Product Change Notice (PCN)

PCN Number: PCN-0450358R-01

Product(s) Affected: SDF-J Series (SDF-40J, SDF-50J, SDF-60J, SDF-80J, SDF-130J)

Reason(s) for Change: Manufacturing build location change.

Old Design SDF-401

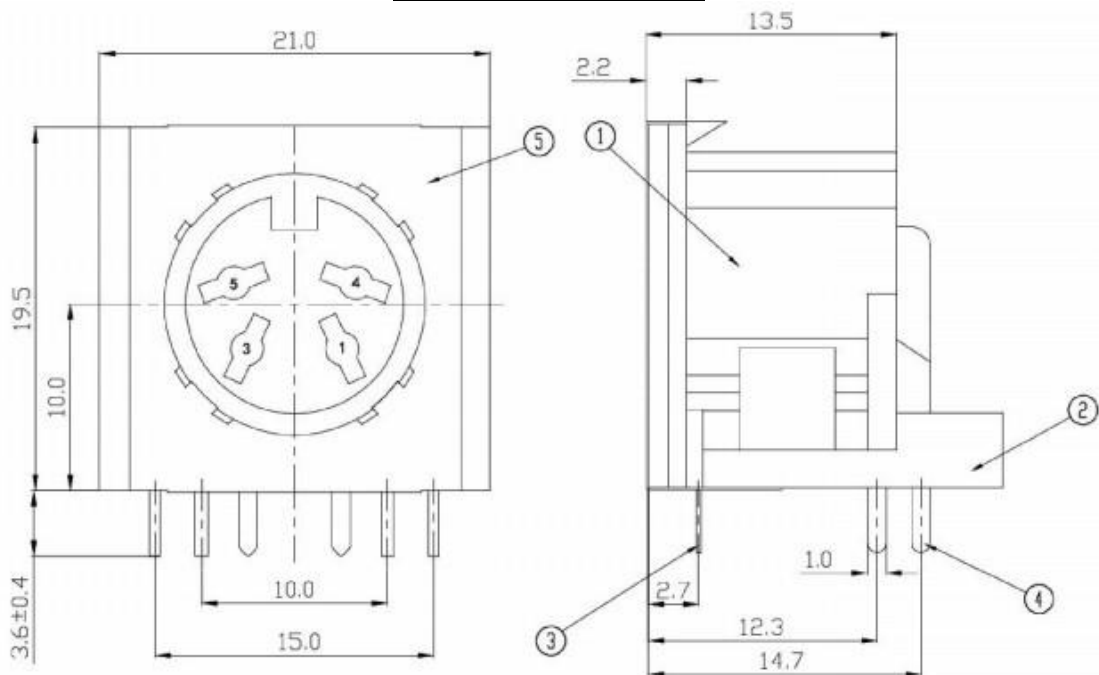
Description of Change: Dimensional and mechanical changes as shown below. Materials changes as shown below. Note that PCB layouts have been adjusted to match the new mechanical changes.

New Design SDF-401

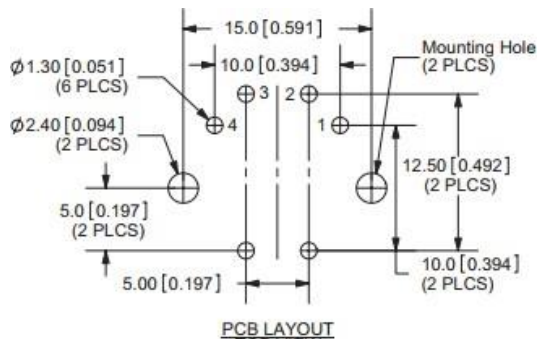
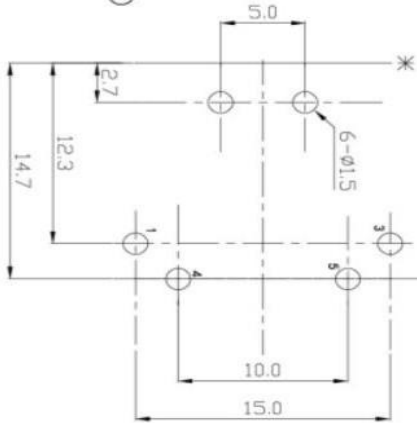
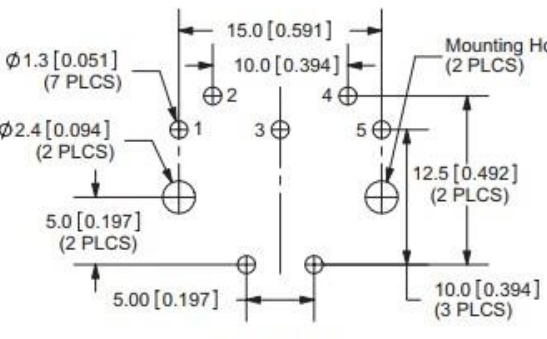
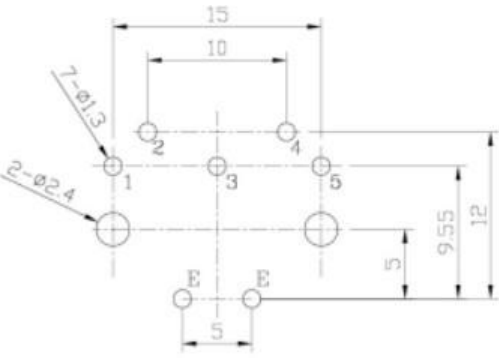
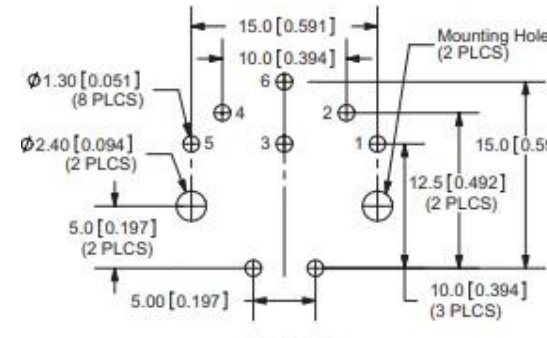
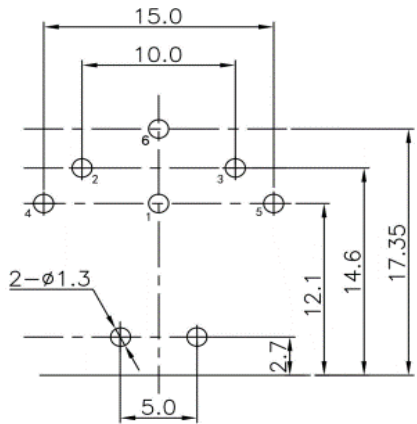
PCB Layout Old Design	PCB Layout New Design
<p><u>4-pin</u></p>  <p>PCB LAYOUT TOP VIEW</p> <p>Dimensions: 15.0 [0.591], 10.0 [0.394], 12.50 [0.492], 5.0 [0.197], 10.0 [0.394]. Features: 6 PLCS (1.30), 2 PLCS (2.40), 2 PLCS (5.0), Mounting Hole (2 PLCS).</p>	 <p>Dimensions: 5.0, 10.0, 15.0, 12.3, 14.7, 2.7, 6-Ø1.5.</p>
<p><u>5-pin</u></p>  <p>PCB LAYOUT TOP VIEW</p> <p>Dimensions: 15.0 [0.591], 10.0 [0.394], 12.5 [0.492], 5.0 [0.197], 10.0 [0.394]. Features: 7 PLCS (1.3), 2 PLCS (2.4), 2 PLCS (5.0), Mounting Hole (2 PLCS).</p>	 <p>Dimensions: 15, 10, 12, 9.55, 5, 5, 2-Ø1.3, 2-Ø2.4.</p>
<p><u>6-pin</u></p>  <p>PCB LAYOUT TOP VIEW</p> <p>Dimensions: 15.0 [0.591], 10.0 [0.394], 12.5 [0.492], 5.0 [0.197], 10.0 [0.394]. Features: 8 PLCS (1.30), 2 PLCS (2.40), 2 PLCS (5.0), Mounting Hole (2 PLCS).</p>	 <p>Dimensions: 15.0, 10.0, 17.35, 14.6, 12.1, 2.7, 5.0, 2-Ø1.3.</p>
